PROJECT NAME: BENNINGTON	
PROJECT NUMBER: BRF 1000(16)	
FILE NAME: z88J087bdr_frame.dgn	PLOT DATE: 8/7/2014
PROJECT LEADER: R. HEBERT	DRAWN BY: S. MORGAN
DESIGNED BY: D. MYERS	CHECKED BY: R. HEBERT
FRAMING PLAN AND CROSS FRAME DETAILS	SHEET 39 OF 75

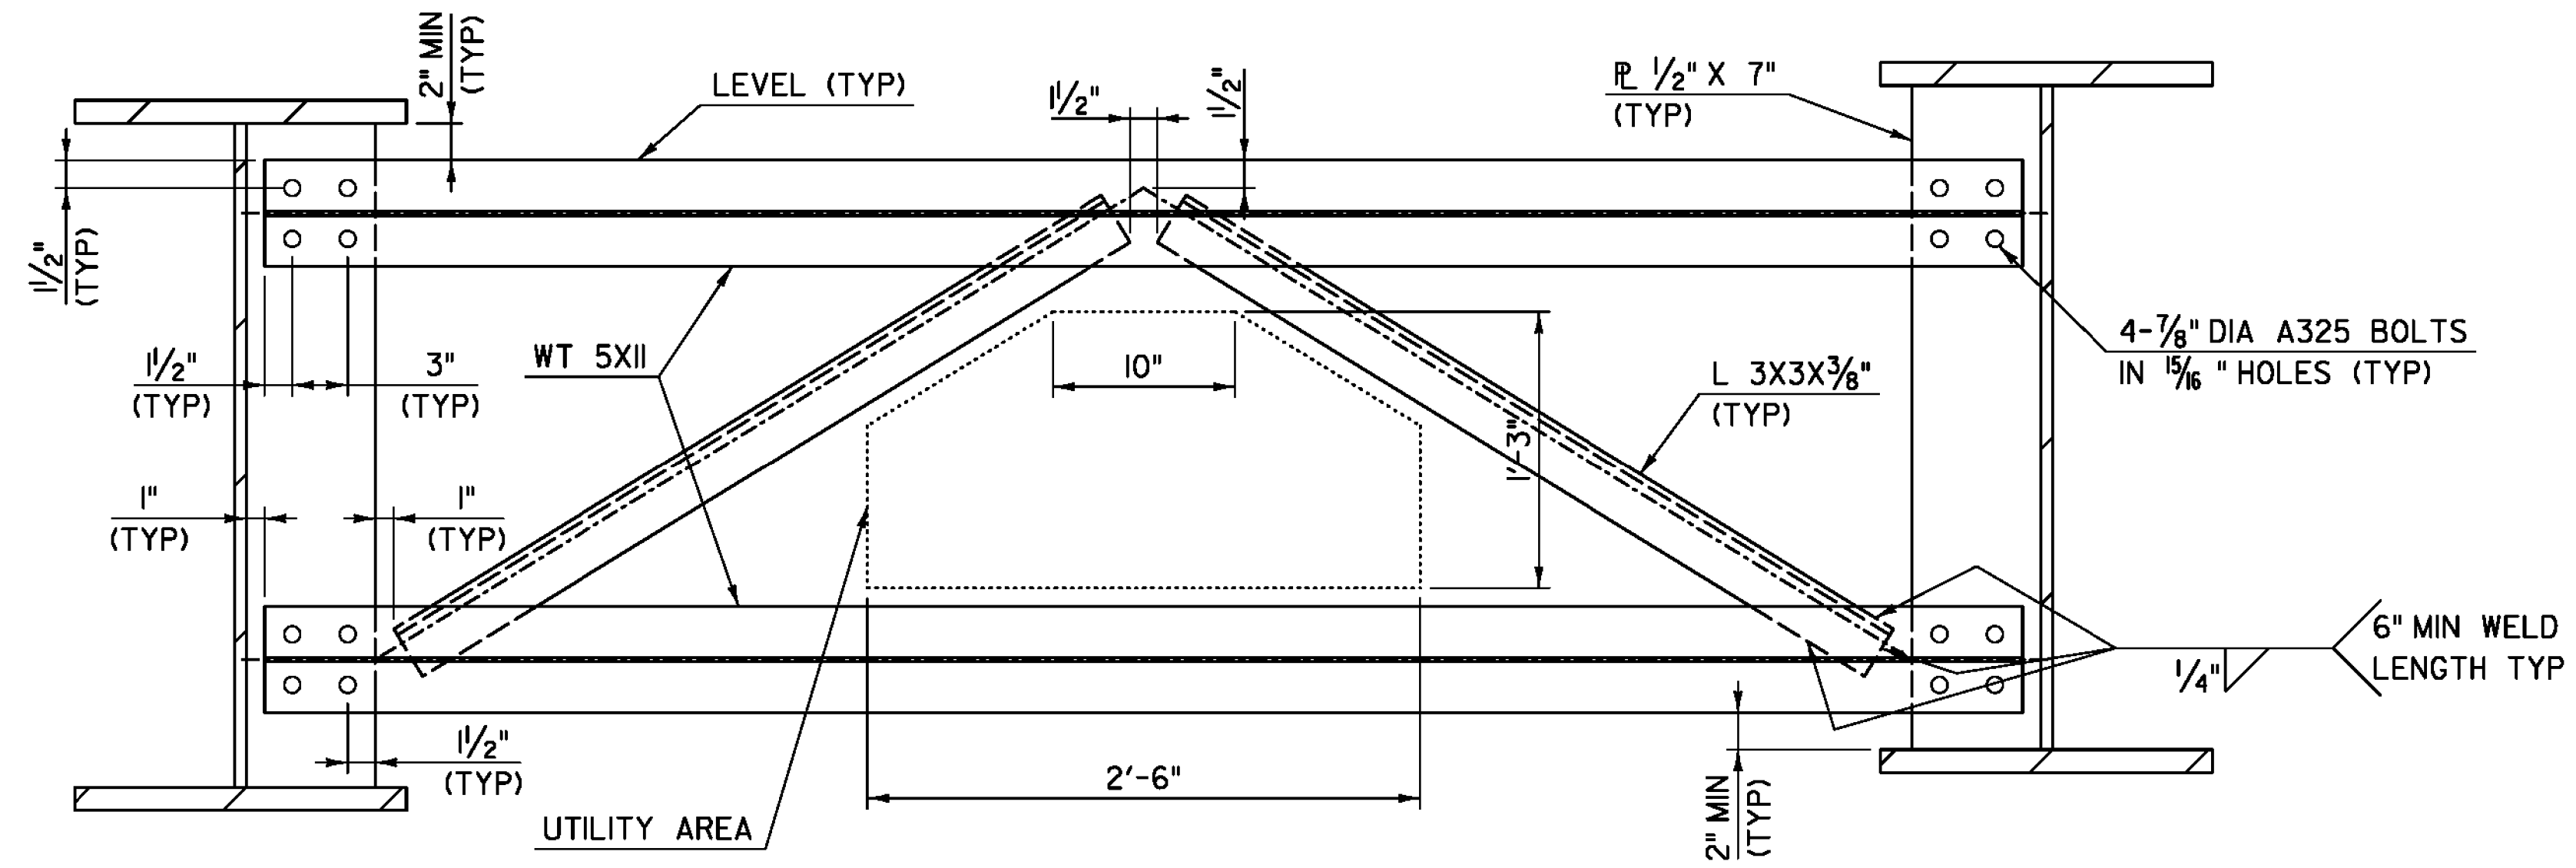
ADDITIONAL UTILITY SUPPORTS FOR DUCT BANK WERE ADDED AS REQUIRED - SEE SHOP DRAWING
